HISTORIC DISTRICT COMMISSION ADDITIONAL INFORMATION REQUEST

Application Number: HDC2025-00054

NAME: Sharif Affas		COMPANY NAME:	
ADDRESS:	CITY:	STATE:	ZIP:
PROJECT ADDRESS: 1760 Wabash			
HISTORIC DISTRICT: Corktown

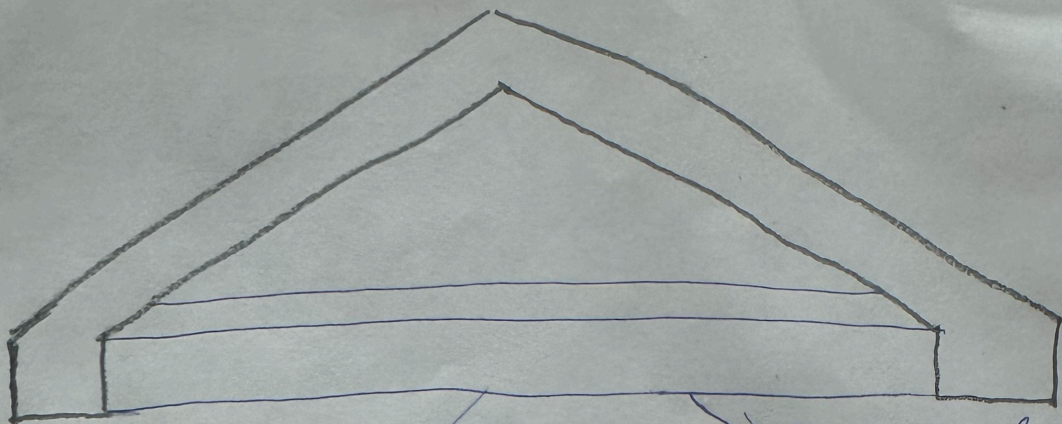
A dimensioned wall section and elevation drawing for each gable of a different design that confirms the proposed design(s), materiality, and decorative treatment. As the original details within the historic gables have been lost, the Commission needs clarity over what is proposed and how it will look once completed. Also, is there photographic documentation of the front gable after the vinyl siding was removed but before the new wood siding was installed?

The removal of the gables was an oversight on our part and miscommunication with our siding contractor when they were removing the siding to fix the insulation and water infiltration issue. We plan to reattach gables to the front and sides of the home, per the attached drawings, and believe it to be near an exact replica of the historic gables. We also plan to install new gables on the new construction of the home to match the approved drawings. The covering up of the gable windows and removal of the casing around the picture window on the front of the home was also an oversight and miscommunication from us and our contractor. After we install the new gables, we plan on changing the siding on the front of the home above the gables to a fishscale siding similar to the siding that exists on the roof of the front porch. All of the original scales are not intact, but we will replicate what currently exists. We do not have a picture of the scale siding after vinyl was removed. The gable window is still intact underneath the siding. We didn't realize the gable windows were covered up, and we didn't notice the removal of the gables, until we reviewed the old pictures after receiving the violation notice. We believe restoring the gables, gable windows, casing around the picture window, and installing fish scale siding on the front of the home above the gables, will give the house a much better appearance. We were wondering what seemed off about the home and this is definitely it.

move fishscale or we could do a
sunburst panel and paint it
a nice vibrant color. currently there is
no original siding. just plywood.

replace
gable

Fish scale to match
this fish scale

replace
gable

→ proposed front Gable Box

↙ cross section
aluminium trim coil

→ wood siding (fascia)

↘ wood soffit.

2x8 Ledger Board

↘ wood rafters
